Amendment to the Drawings:

REMARKS/ARGUMENTS

Fig. 5

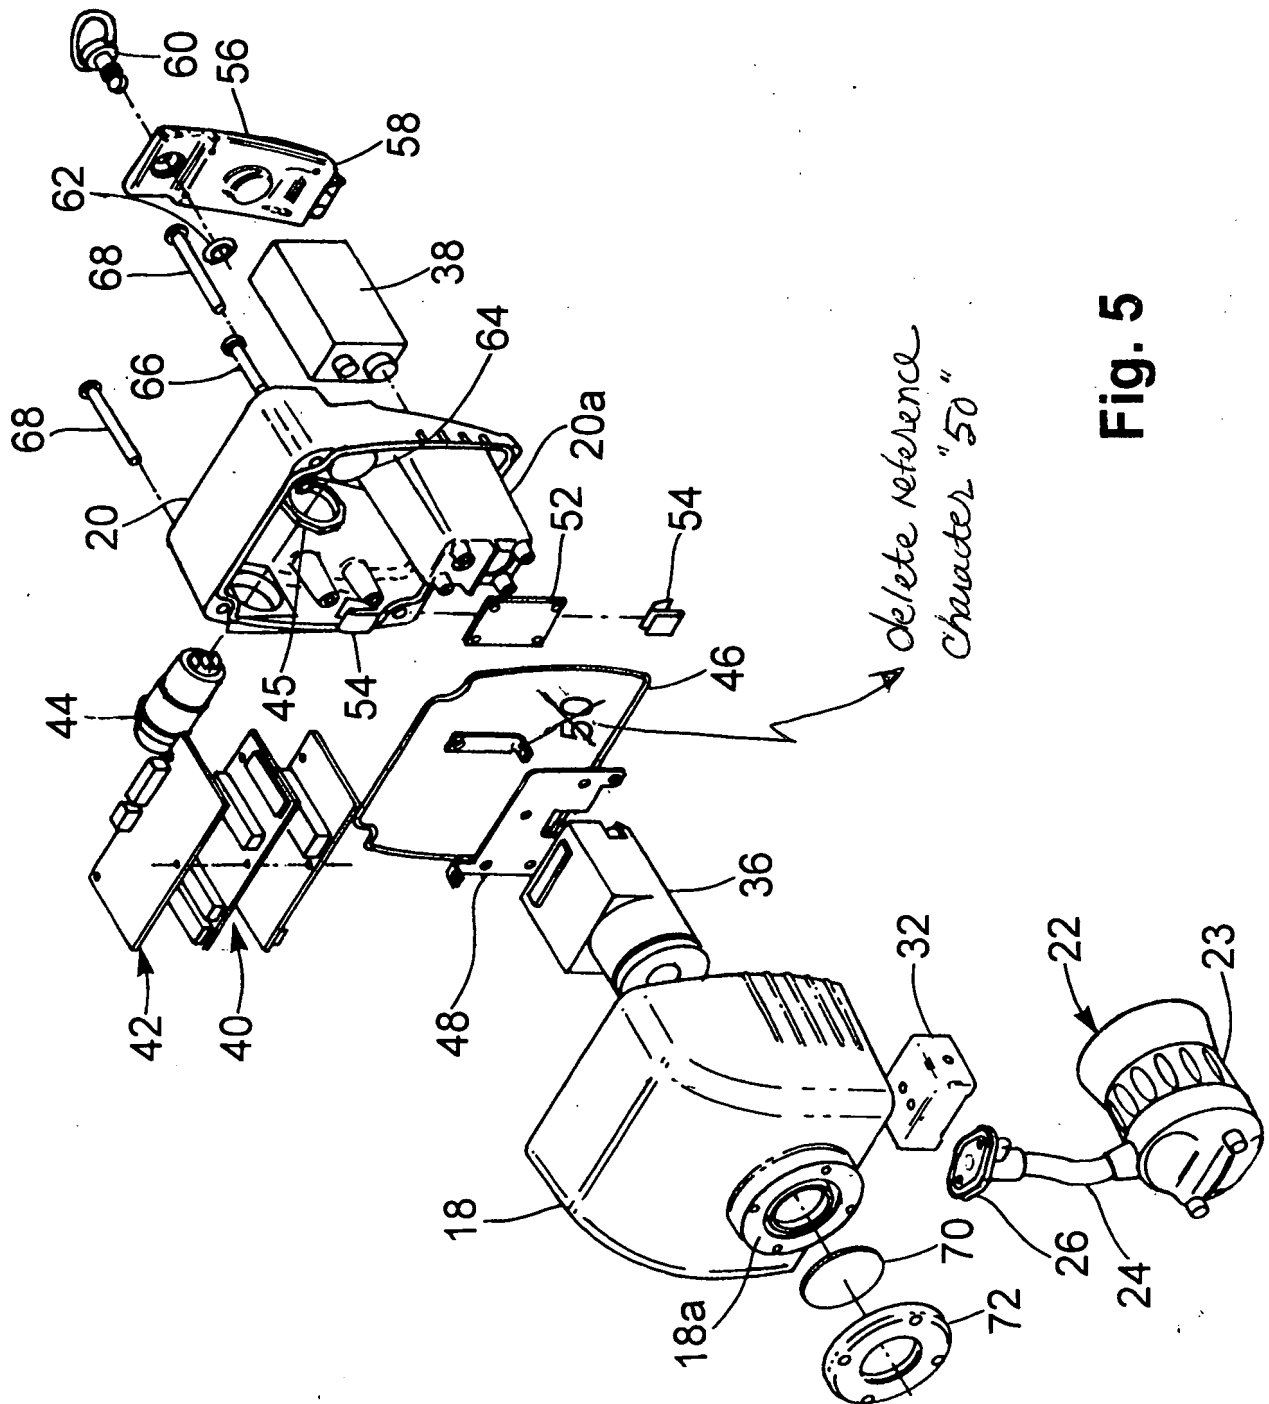
The attached drawing sheet of Fig. 5 includes a change made thereto and replaces the original drawing sheet of Fig. 5. In Fig. 5, the reference character “50”, not mentioned in the description, has been deleted, as is indicated in the annotated drawing sheet further attached.

The drawings, particularly Fig. 5, were further objected to by the Examiner for failing to comply with 37 CFR 1.84(p)(5), in this case for designating the reference character "50" not mentioned in the description. Applicants acknowledge this non-compliance and have accordingly amended Fig. 5 to remove the unnecessary reference character. A proper "Replacement Sheet" for Fig. 5 as well as an annotated sheet indicating the corrective action are submitted herewith in compliance with 37 CFR 1.121(d), and the objection to the drawings should now be removed.
